Peach Bottom Atomic Power Station, Units 2 and 3  
Facility Operating License Nos. DPR-44 and DPR-56  
NRC Docket Nos. 50-277 and 50-278

Subject: Extended Power Uprate License Amendment Request – Supplement 4  
Response to Request for Additional Information - Extended Power Uprate

**Response to Request for Additional Information – EEEB**

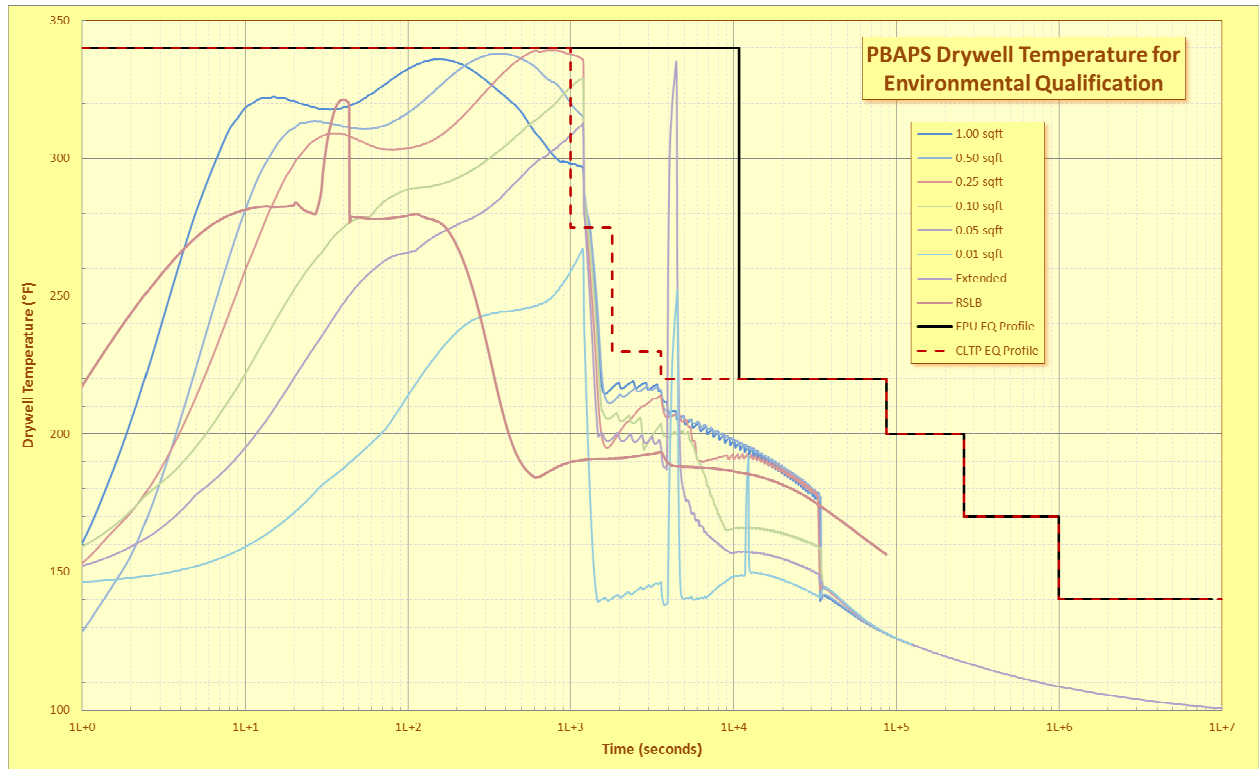
In Figure 2.3-1 of Attachment 4 to the application dated September 28, 2012, the licensee presented the current EQ temperature profile and revised post-EPU EQ temperature profile, for the drywell (DW). Update this profile for the equipment to show that the equipment remains qualified for the temperature in the DW under EPU conditions. Provide a containment LOCA/MSLB Accident Pressure profile curve vs. the plant EQ profile.

Drywell Temperature Profile:

The Small Steam Line Break (SSLB) is the limiting event for DW temperature. The figure below provides the composite profile of PBAPS SSLB drywell temperature and the bounding EQ temperature profile. The only impact of the EPU on the EQ temperature profile was an increase in the duration of the peak temperature. This impact was evaluated as described in response to EEEB RAI-1 above. The results of the EQ evaluation concluded that the environmental qualification of EQ equipment was not impacted by EPU and therefore remains qualified for post-EPU operation. The SSLB temperatures profiles are also shown in Figure 2.6-10 of Attachments 4 and 6 of the PBAPS EPU LAR.
